CITY OF FREDERICKSBURG HISTORIC REVIEW BOARD

TUESDAY, SEPTEMBER 13, 2022

6. CERTIFICATE OF APPROPRIATENESS APPLICATIONS

1 BUILDING 421

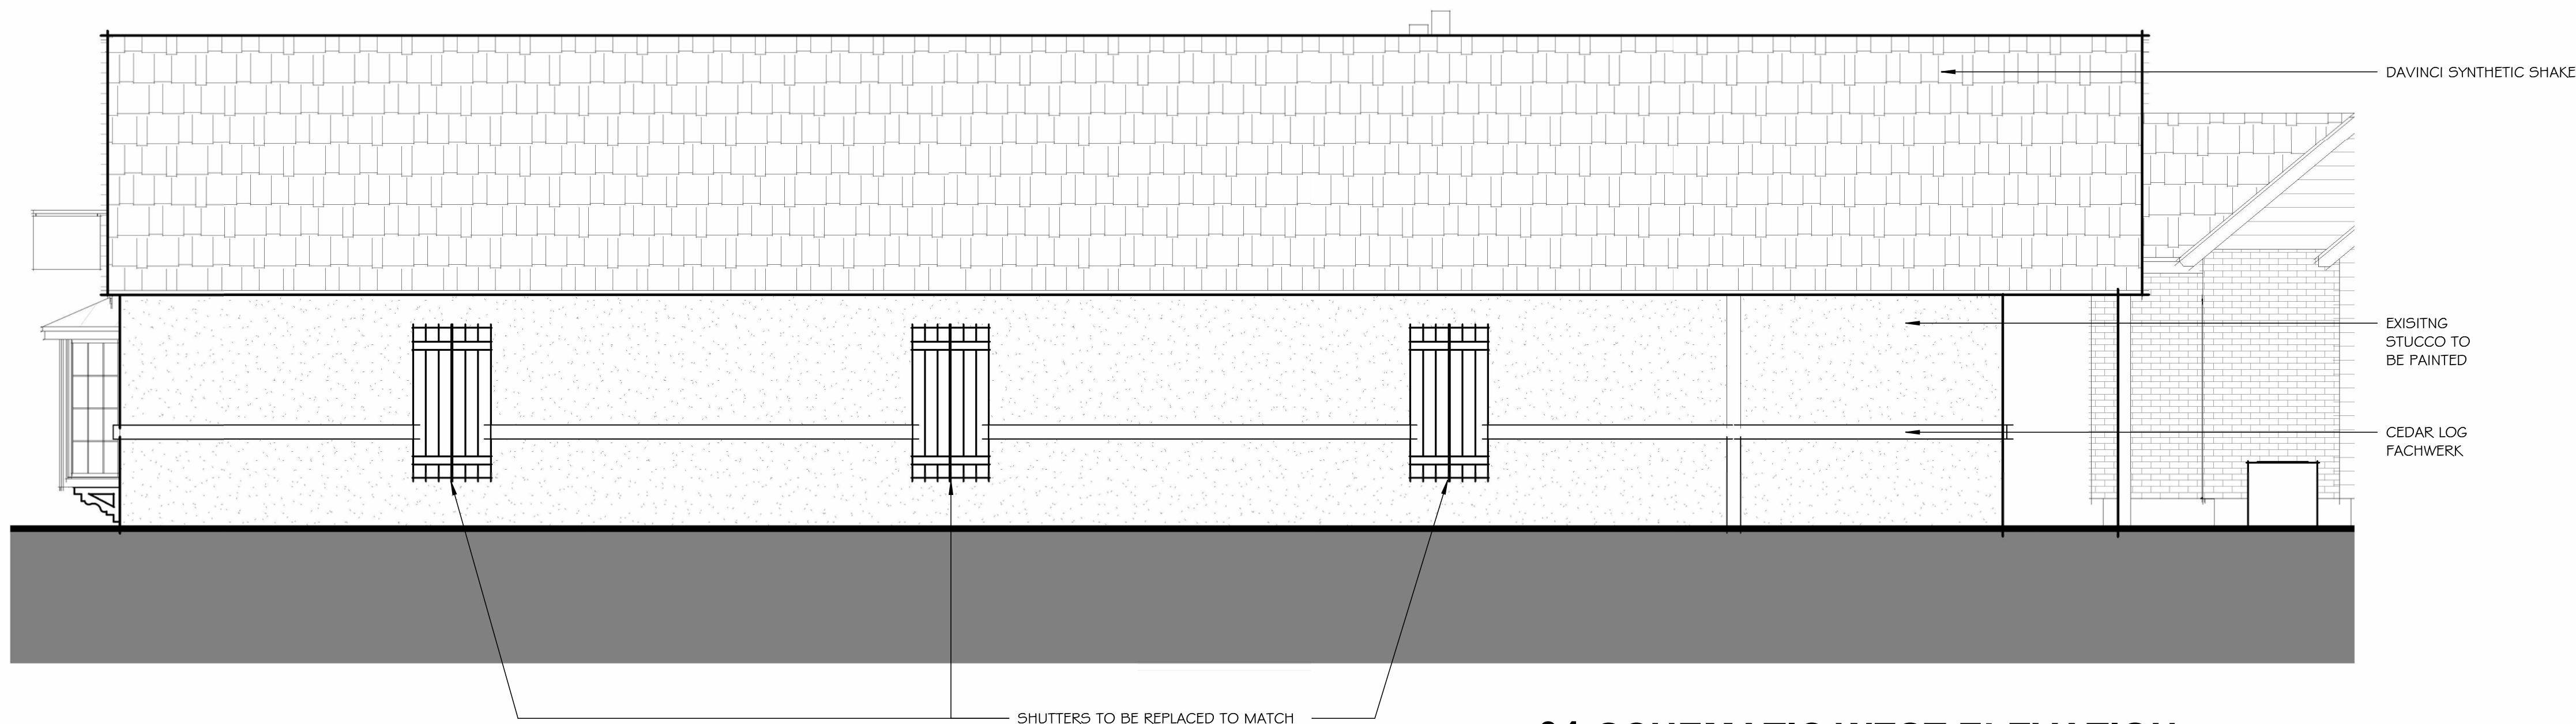
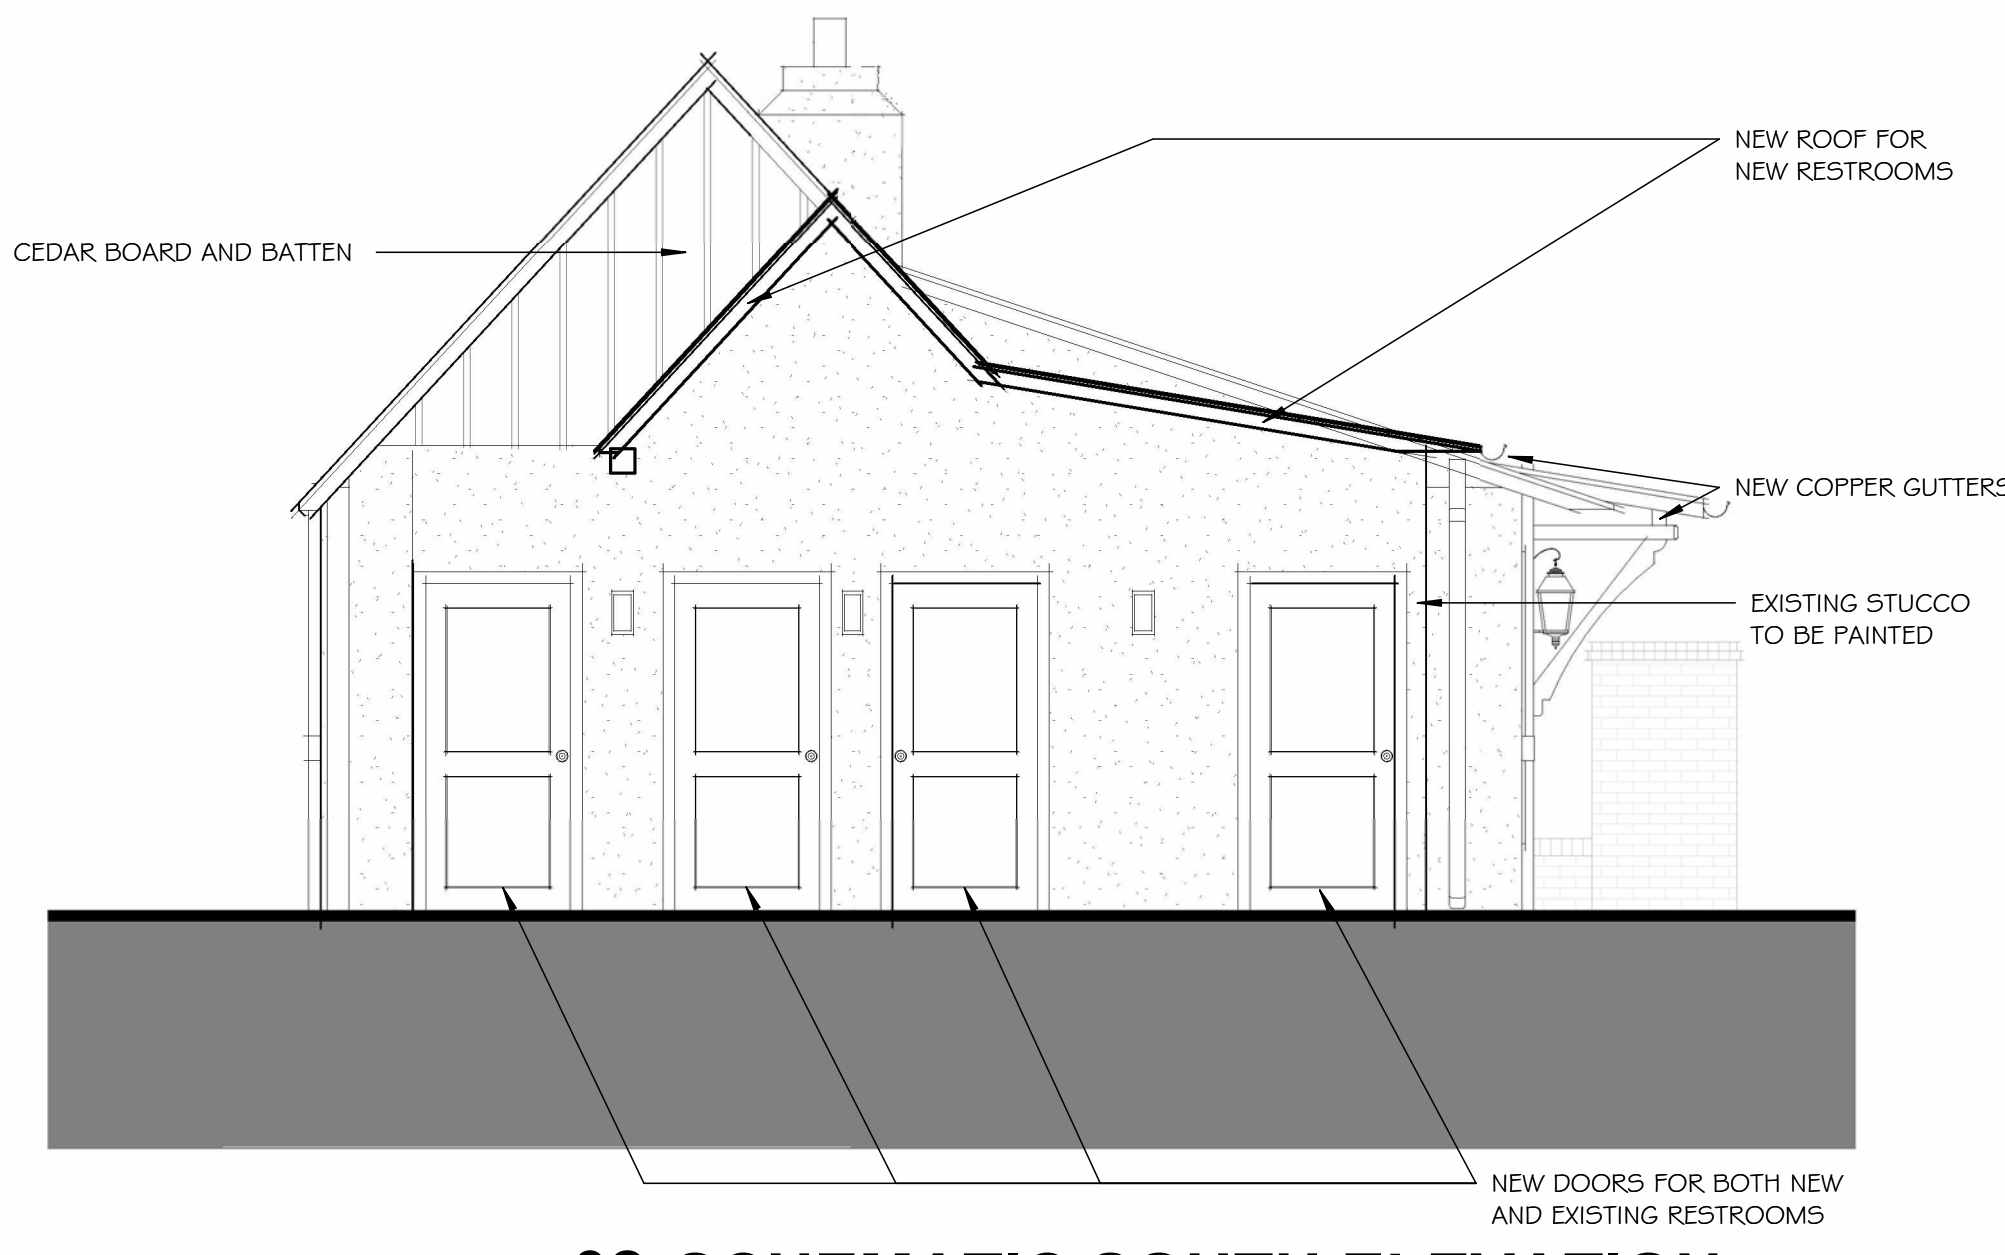
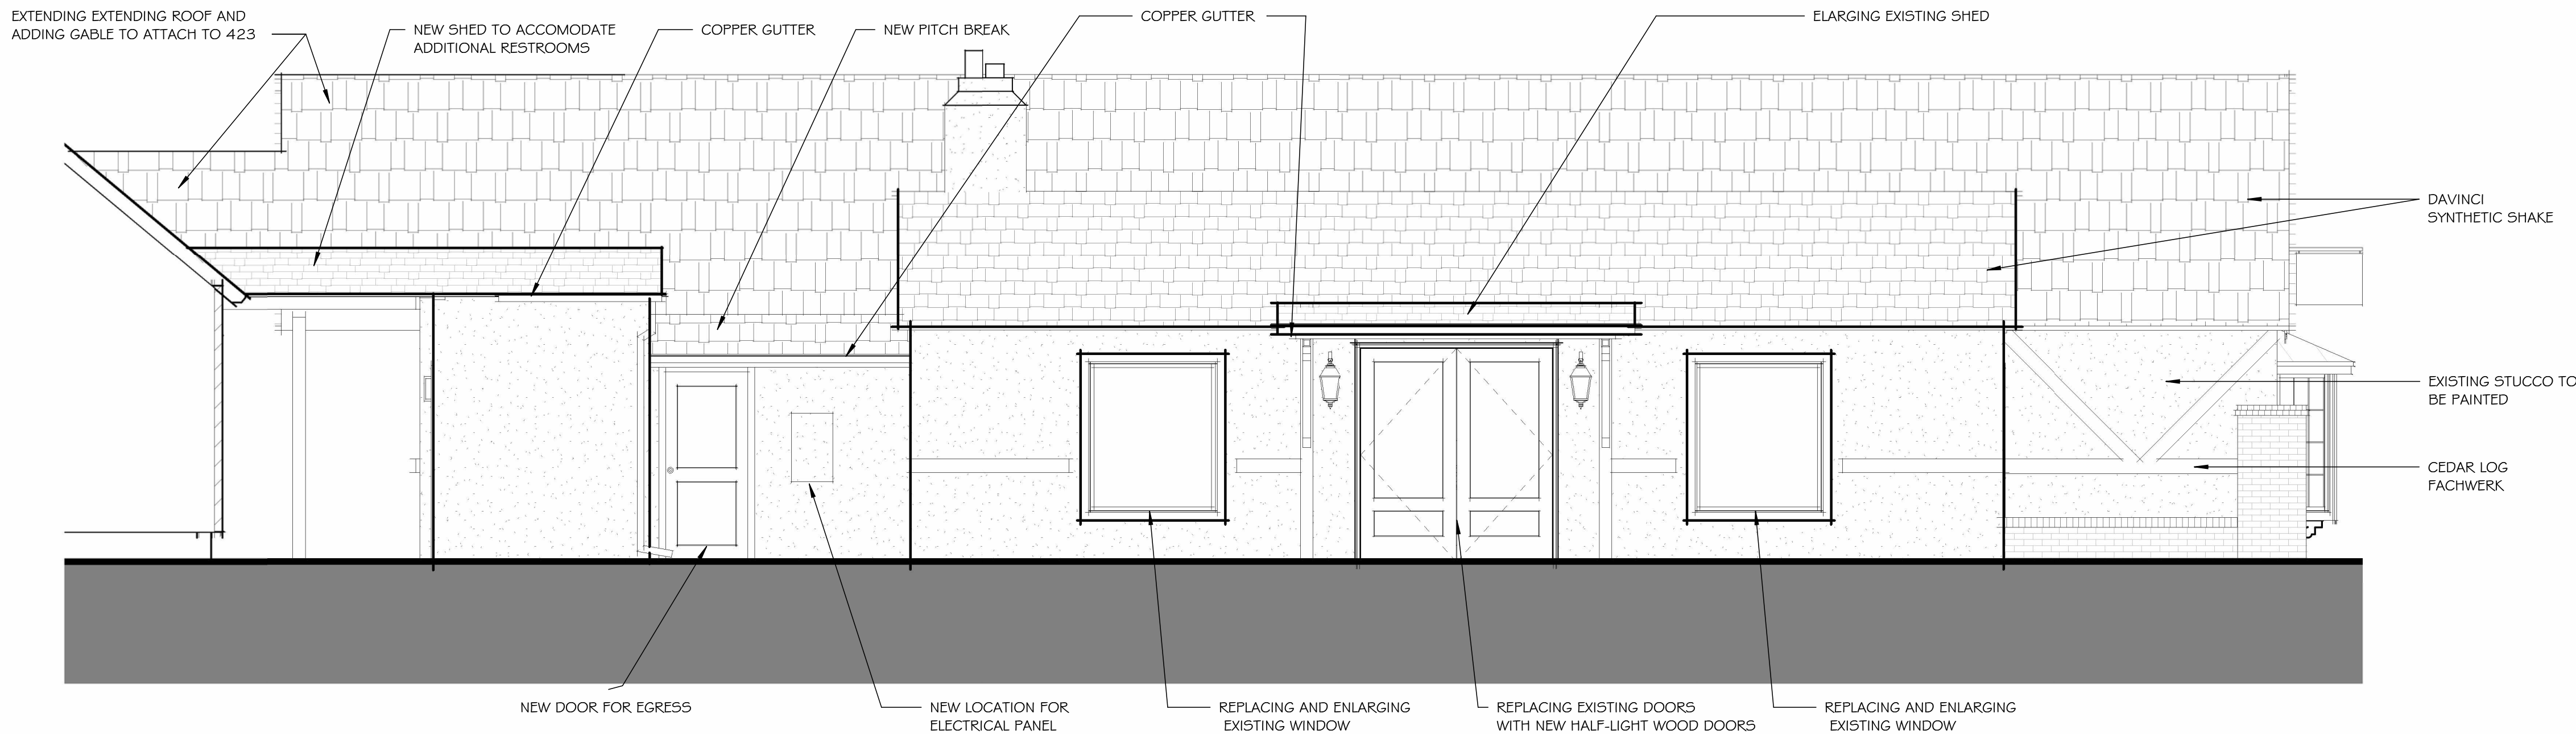
1. Replace the following existing windows with new metal clad windows with similar clad as existing to be clarified in elevations
 - a. Enlarging north facing bay window and replace with similar window style and configuration to original

- b. Removal of window on east wall due to conditions change in the interior. Window would be interrupted by an interior wall
 - c. Replacing window on east façade to remove divided light to match the other windows on the building

- d. Windows to be Marvin Ultimate Picture windows
2. Alterations to brick walls
 - a. Extruding mortar to be removed and repointed
 - b. Whitewash or painted (TBD) will be added in order to even out previous paint applications that have left the surface with uneven colors and layers of paint

- c. If painted, the color will match surrounding buildings
3. Wood siding on west exterior wall to be painted to match surrounding buildings
4. Window to be added to match existing window on east façade for additional natural light; reference plan and elevation

5. Two exits, half-light wooden doors, to be added to north exterior for access to new and existing restrooms on the south end of 421 Main St.
6. Replace window on east wall with a pair of half-light wooden doors for flow and egress

- a. Awning to match main façade to be added for weather protection
 - b. Shown in plan and elevation
7. Replace eastern main façade doors with a pair of half-light wooden doors to provide continuity in overall design aesthetic
